## ADDENDUM NO. 3

First Community Branch Bank Brookland, AR

Project #1654

March 3, 2020

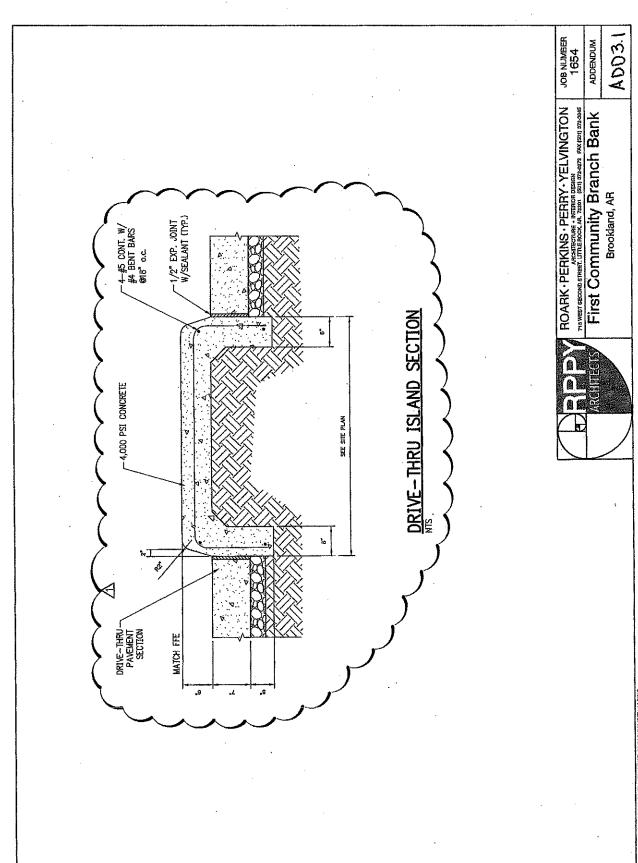
- c. No vehicles will be allowed to park on the grass/shoulder along 49 during construction.
- E. Refer to attached new drawing ADD3.1 for Drive Thru Island section.
